## DECISION OF 3713<sup>th</sup> COUNCIL MEETING HELD ON TUESDAY 29 JANUARY 2019

### 14. **CiS02: NSW Government Plans for St Leonards and Crows Nest - Detail**

**SUBJECT:** NSW Government Plans for St Leonards and Crows Nest - Detail**AUTHOR:** Emma Booth, Team Leader Design**ENDORSED BY:** Joseph Hill, Director City Strategy**EXECUTIVE SUMMARY:**

Figure 3. Proposed foreshore link

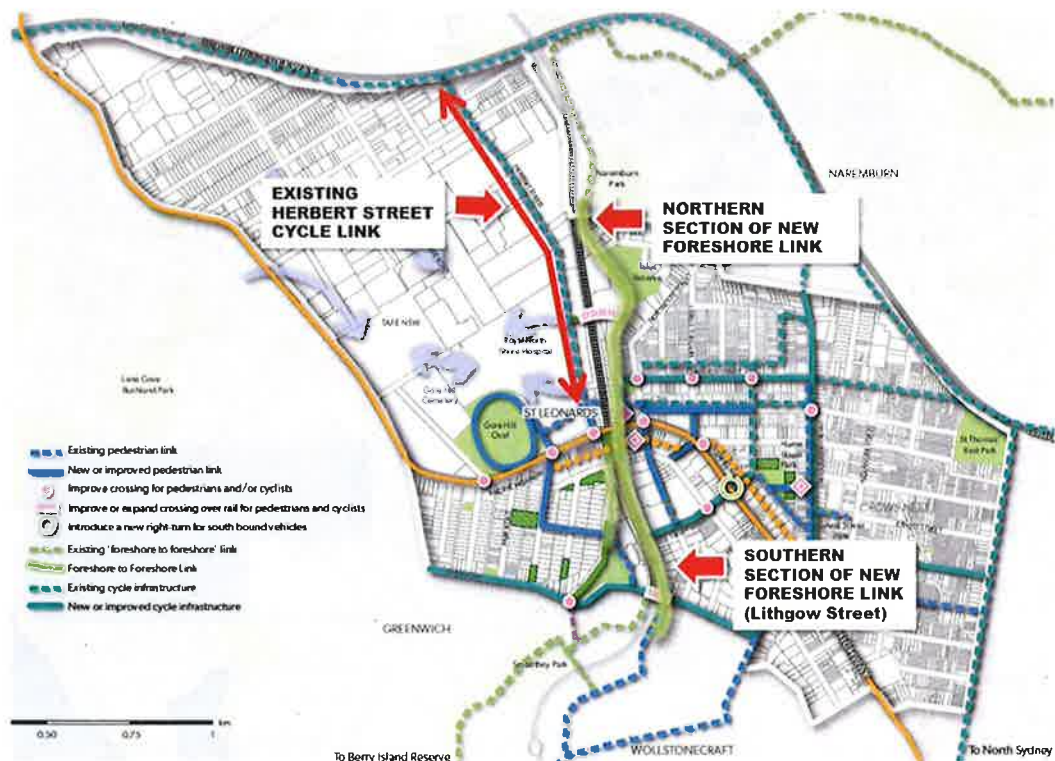
increase pedestrian/cyclist conflict. This facility would also duplicate existing cycle lanes on Herbert Street. Upgrading Herbert Street cycle lanes (separated uni-directional cycle lanes) as well as delivering the proposed cycle link from Herbert Street over the railway line to Chandos Street, via the bridge opposite the RNSH, would improve this connection at a significantly lower cost than the proposed Foreshore to Foreshore link as well as more directly servicing RNSH cycling demand.

While the Lithgow Street section of the foreshore to foreshore link may form part of the North District Plan's "Green Grid", on this occasion the Green Grid does not coincide with a section of Sydney's Principal Bicycle Network. At best, this facility is likely to perform a local or recreational cycling function. While there may be some localised amenity benefits for adjacent residents, it is unlikely to achieve the productivity and sustainability benefits that would be achieved by delivering a more strategic section of Sydney's principal bicycle network (e.g. Pacific Highway cycle lanes). Given the significant cost of this initiative (\$46M), this may require serious reconsideration.

Figure 4. Main open space proposals funded by the new state levy (NSC image)

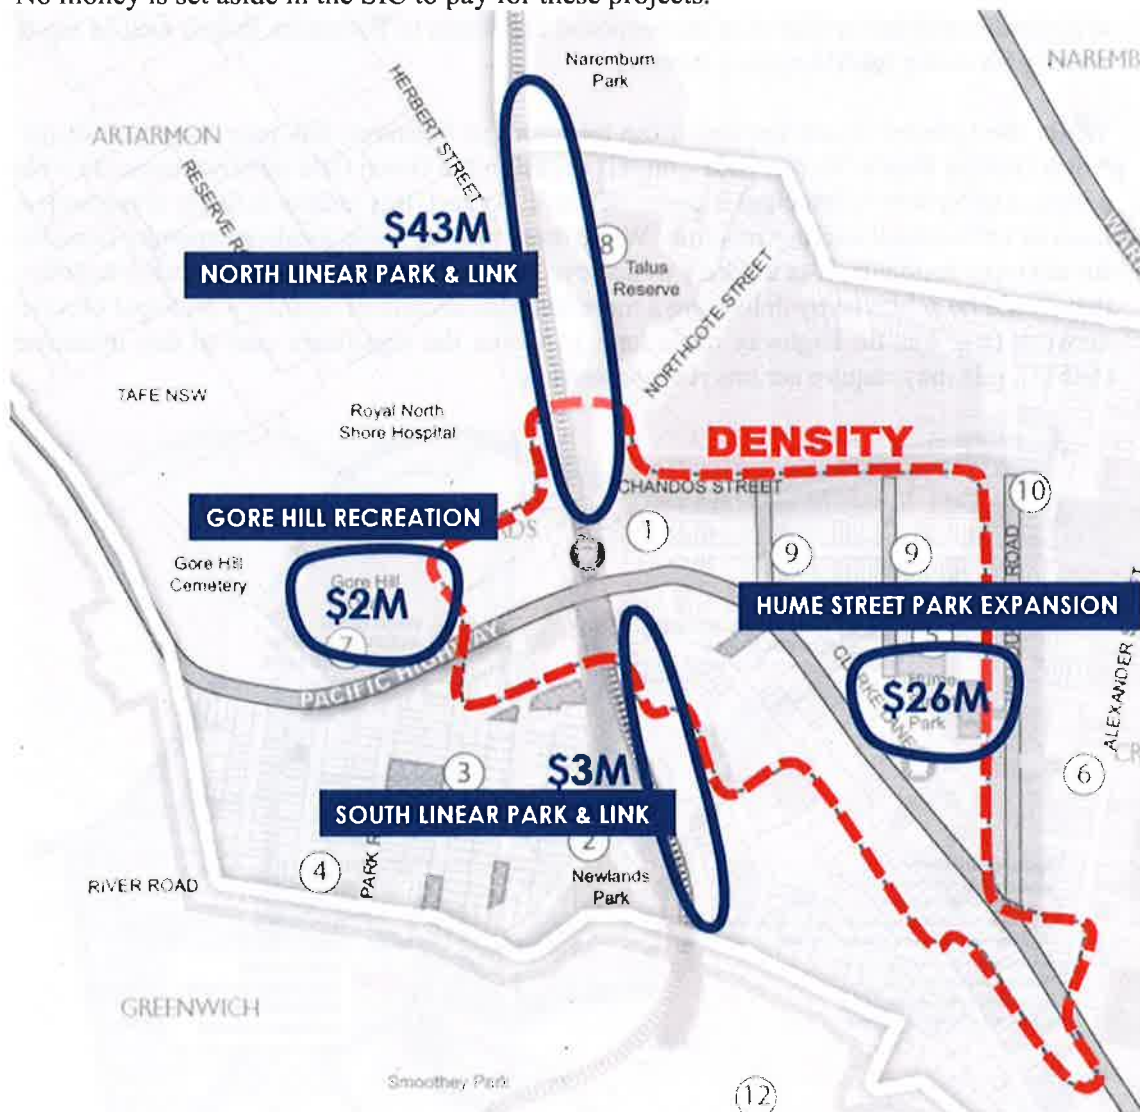
- The \$46M 'Foreshore to Foreshore' link that is to run from Talus Reserve in the Willoughby LGA through to River Road in the south;
- The \$26M proposal to expand Hume Street Park; and
- \$2M contribution towards the Gore Hill recreation facilities.

The *2036 Plan* reinforces Council's plans to deliver linear parks along Mitchell and Oxley Streets and introduce setbacks along the Pacific Highway to make room for more tree planting. No money is set aside in the SIC to pay for these projects.
